FORD:

2011-2016 F-Super Duty

ISSUE

Some 2011-2016 F-Super Duty crew cab pickup vehicles equipped with an 8 foot box and a factory trailer hitch may exhibit a vertical vibration, often described as hopping, from 68-112 Km/h (42-70 MPH).

Figure 1 - Article 16-0087

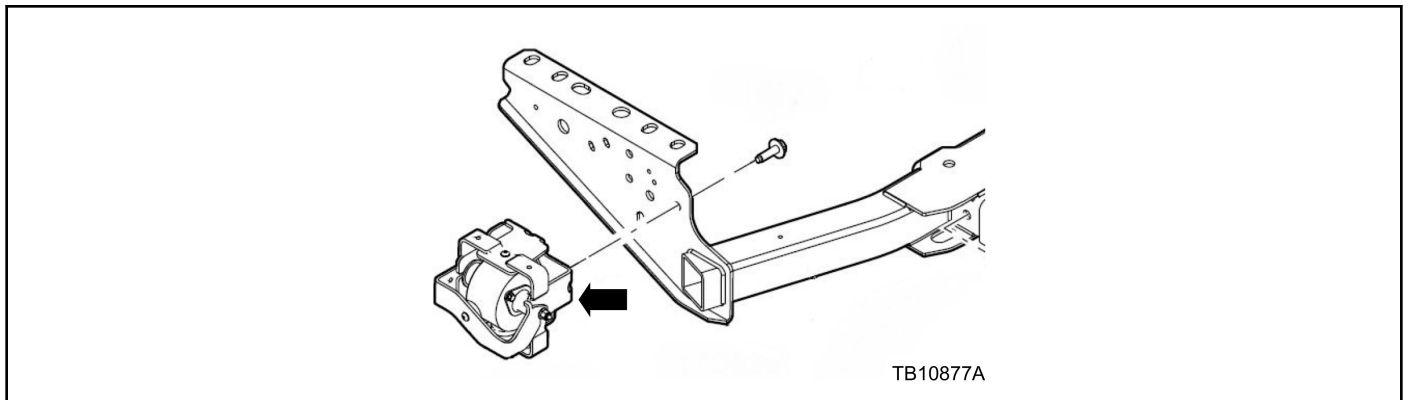
1. Does the customer describe a vibration, which may be described as hopping, at approximately 68-110 Km/h (42-70 MPH)?
 - a. Yes - proceed to Step 2.
 - b. No - this article does not apply. Refer to Workshop Manual (WSM), Section 100-04 for normal diagnostics.
2. Does the vehicle have a cage damper mounted to the factory trailer hitch on the driver side? (Figure 1)

- a. Yes - this article does not apply. Refer to WSM, Section 100-04 for normal diagnostics.
 - b. No - proceed to Step 3.
3. Remove the wiring connector on the driver side of the trailer hitch. (Figure 2)

Figure 3 - Article 16-0087

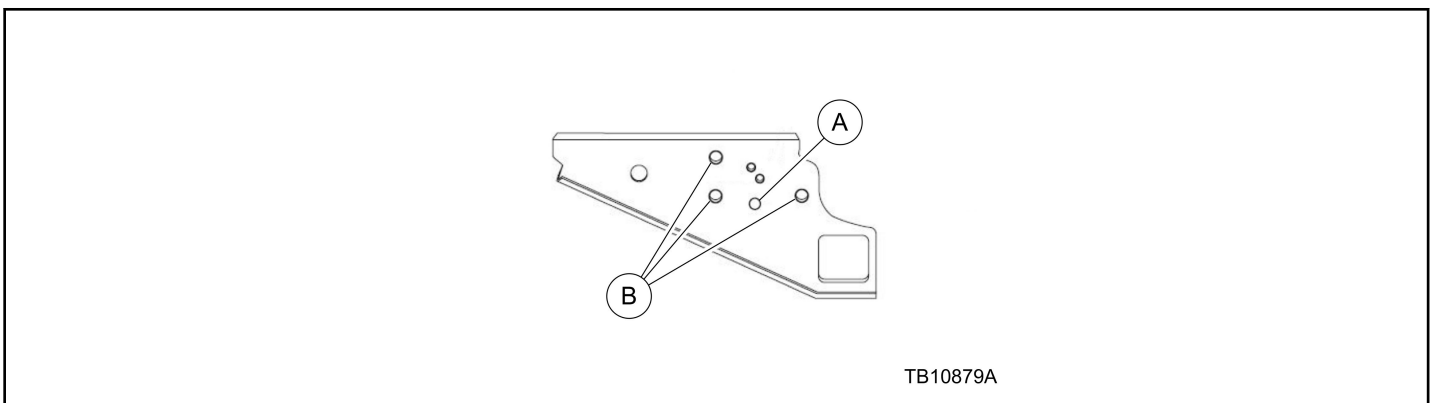
4. Locate in the driver side plate of the trailer hitch the following holes. (Figure 3)
 - a. Clearance hole 17.6 mm (11/16"). The clearance hole will be used for the cage damper rubber pad. (Figure 3A)
 - b. Three mounting holes 14.6 mm (9/16"). (Figure 3B)

Figure 4 - Article 16-0087

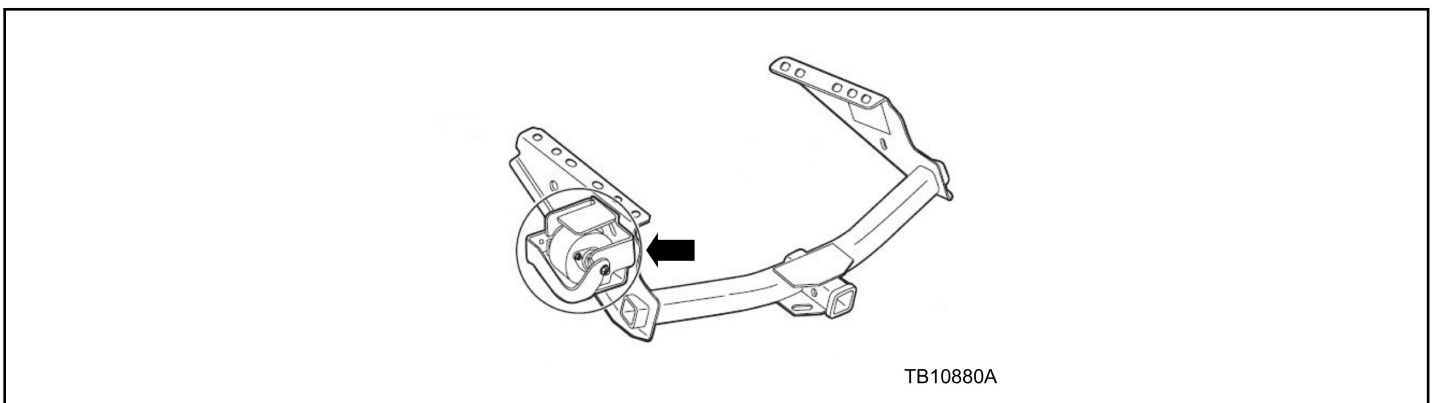
5. Mount the cage damper and install the bolts. Tighten to 63 Nm (46 lb-ft). (Figure 4)
